# **AIR FORCE INSTALLATION RESTORATION PROGRAM**

EXPLANATION OF SIGNIFICANT DIFFERENCES  
FINAL

SOIL OPERABLE UNIT SITES  
AND GROUNDWATER OPERABLE UNIT PLUMES  
RECORD OF DECISION FOR SITES 56, 59, AND 60

AIR FORCE BASE CONVERSION AGENCY  
MATHER, CALIFORNIA

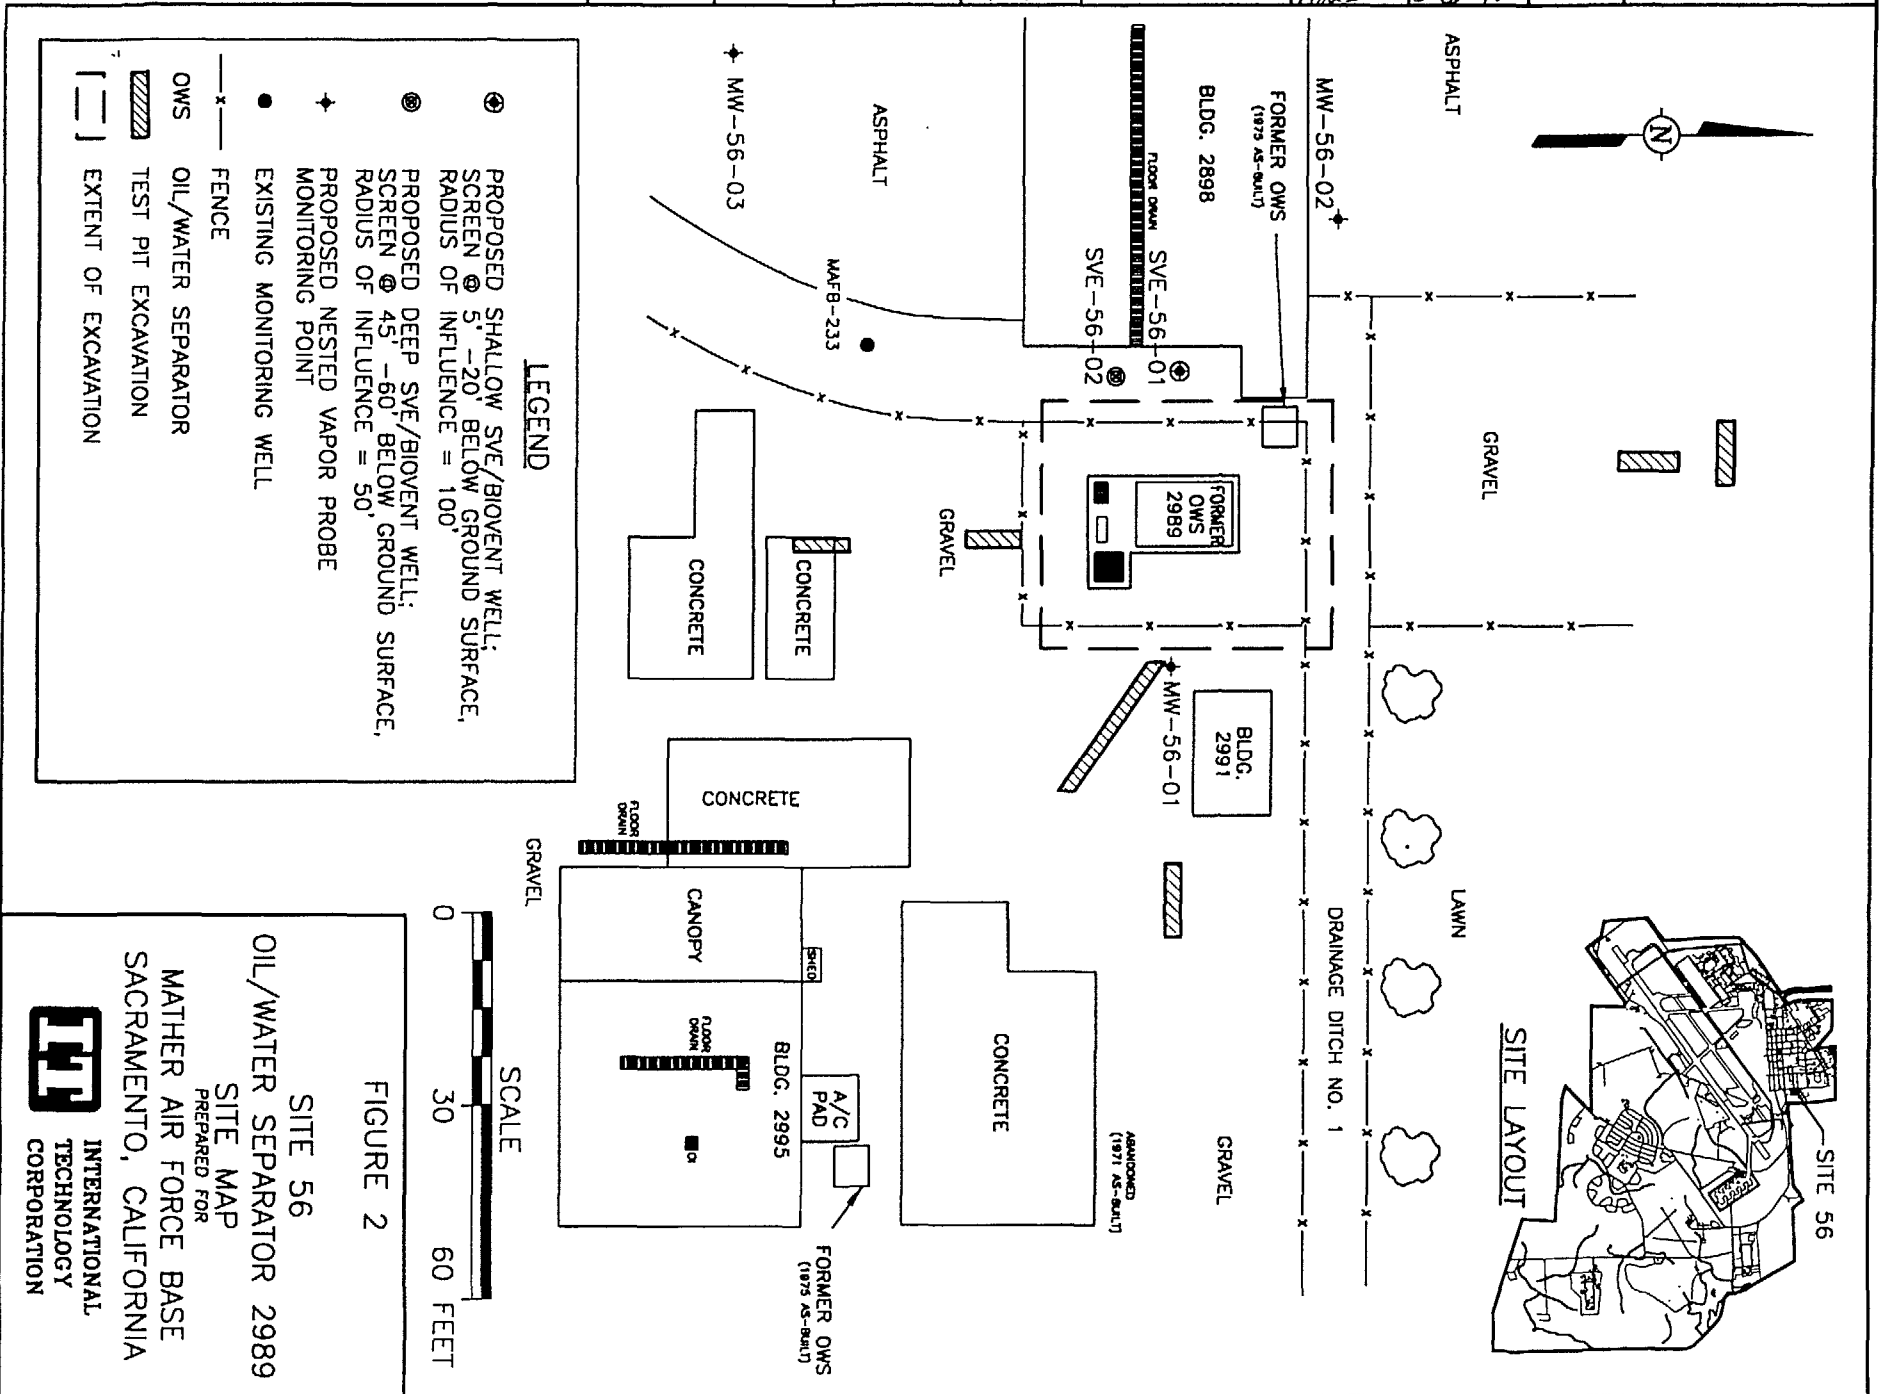
CRWQCB 3.    Comment:   Figure 2 - page 5, Figure 3 - page 7, and Figure 4 - page 8: All three figures do not include a legend or indicate the areas that were previously excavated, the potential location of the treatment systems, or the location of any remaining surface contamination targeted for excavation (e.g., Site 59). These figures should be revised to allow easier review of the ESD by the public.

DTSC 3.       Comment:   The three maps (Figures 2, 3, and 4) are inadequate. They do not have the locations of the actual Oil Water Separators (OWS) marked, they do not show the extent of the former excavations and they have unnecessary lines and markings that are not related to the ESD. Please provide an overall base map to show the location of these sites in relation to each other and to the other IRP sites.

USEPA 2      Comment:    Page 5, Figure 2, Site 56 - Please delineate the estimated extent of contamination and delineate the extent of previous excavation.

Response: **Comment Accepted. All three figures were revised to indicate delineated areas of previous excavations and to aid in the identification of major site features. Approximate locations of treatment systems were located as depicted in the Technical Plans.**

**Response:   Comment Accepted. See response to comment CRWQCB 3.**

Response:    **Comment Accepted. See response to CRWQCB 3.**

FIGURE 3

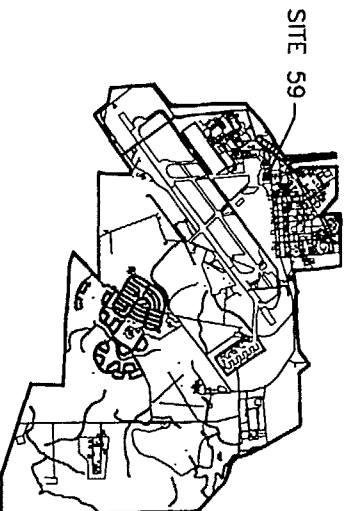
CRWQCB 7. Comment: Section 3.2.2, page 16: The last sentence of the second paragraph states that contaminated surface soil was discovered during the installation of groundwater Remediation water line. A brief narrative on this contamination should be included in the ESD which describes when the contamination was discovered, what action was taken, the concentration and type of contamination encountered, and why this contamination is being addressed in this ESD. The location of this contamination should also be indicated on Figure 3, page 6.

USEPA 3      Comment:    Page 7, Figure 3 - Show the location of the former OWS, delineate the known extent of contamination, and extent of previous excavation.

Response:    **Comment Accepted. See response to CRWQCB 3.**

**FIGURE 4**

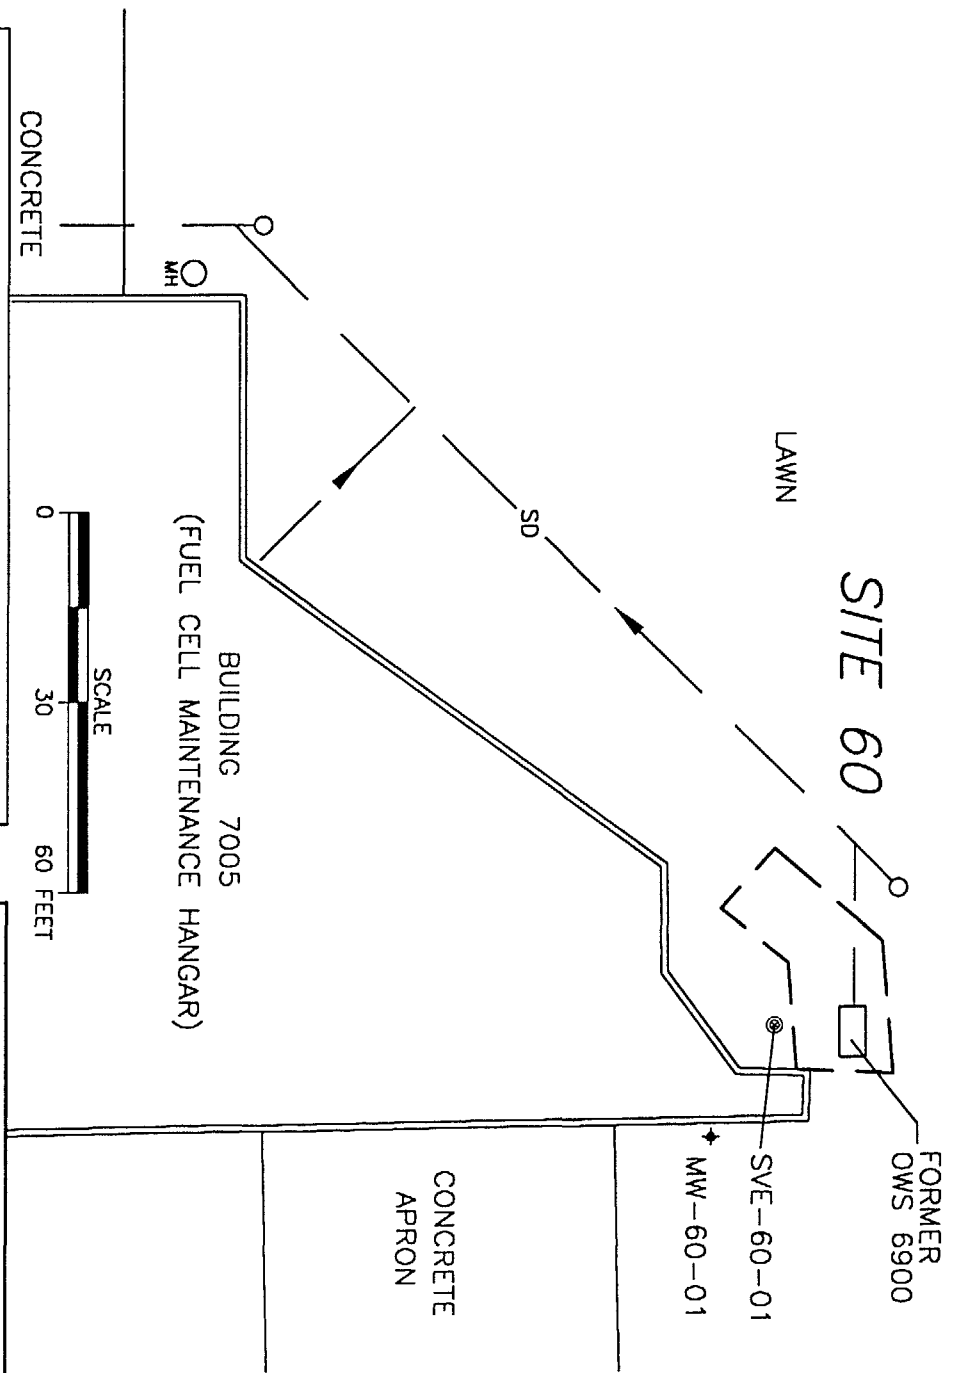
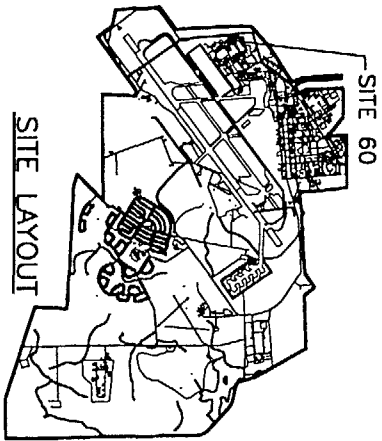
USEPA 4      Comment:    Page 8, Figure 4 - Same comment as comment number three.

Response:    **Comment Accepted. See response to CRWQCB 3.**
